APPLICATION STATUS – INITIAL ASSESSMENT COMPLETE

Application No.:	eDA0189/25
Proposed development:	Demolition of existing structures, lot consolidation and construction of a residential flat building development with basement car parking and associated works - SEPP (Housing) 2021 - Threatened Species Development
Property:	7-11 Pockley Avenue Roseville NSW 2069

Figure 2: Plan showing exceedance of building height

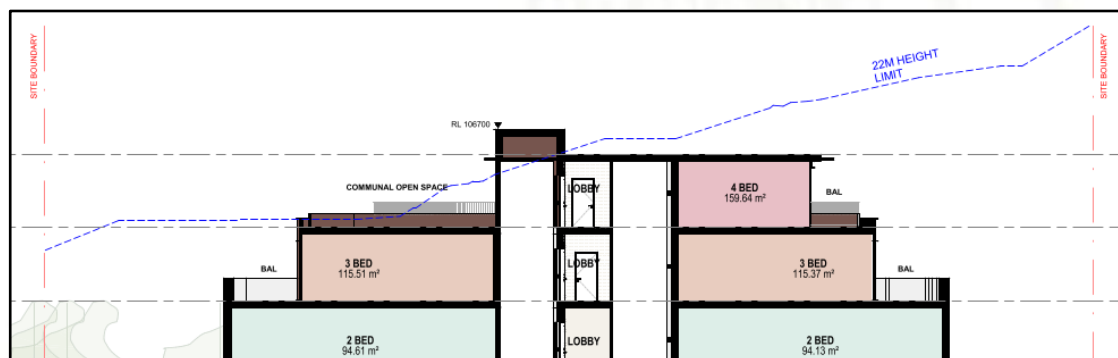
3. The proposed roof top mechanical plant is not supported, as the proposed building height exceeds the permitted 22 metres by 1.98 metres, which is unacceptable, for the following reasons:

- i. the representation of the exceedance of building height is shown within Figure 2 (below)
 - ii. the height is exacerbated by the Finished Ground Floor level, above the basement, is more than 1 metre above the natural ground level

- iii. the appearance of Level 6, containing two units with flat roof, as seen from the eastern elevation, is seen as a 'pop-up', which does not contribute to the overall appearance of the development

- iv. subject to the location of True North mentioned earlier, the design creates shadow impacts on No. 15 Pockley Avenue.
 - v. the roof top terrace/podium level creates overshadowing onto adjoining land, and

- vi. creates a rooftop lift overrun that could be designed within the basement.

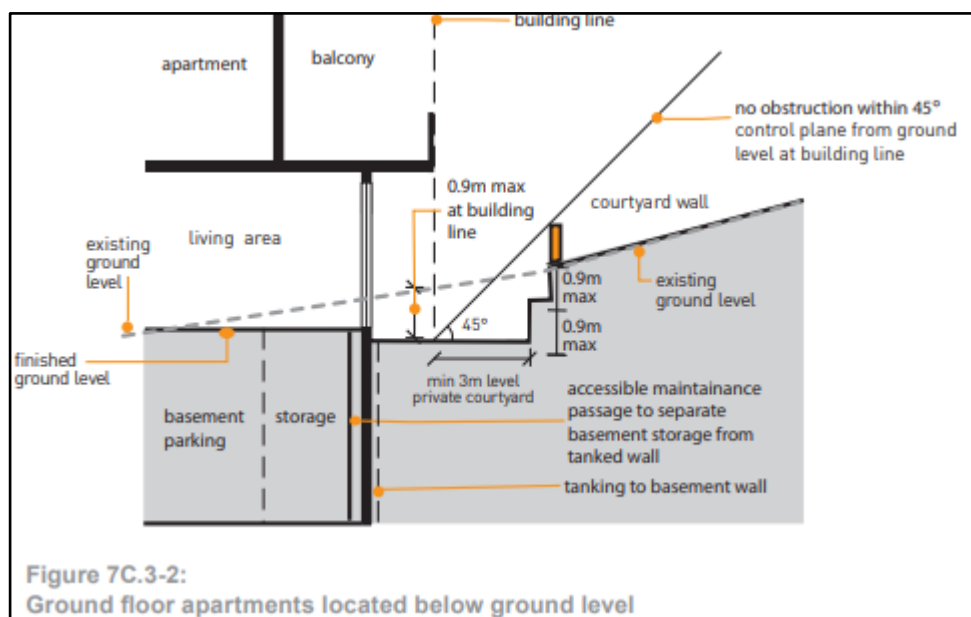
- 22. The large basement communal storage area at Upper Ground Level, shown on plans DA.01.11A, appears to be subterranean and not be separated from a tanked wall by an accessible maintenance passage. An accessible maintenance passage, as shown by Figure 7C.3-2 of the DCP (shown below) is required:
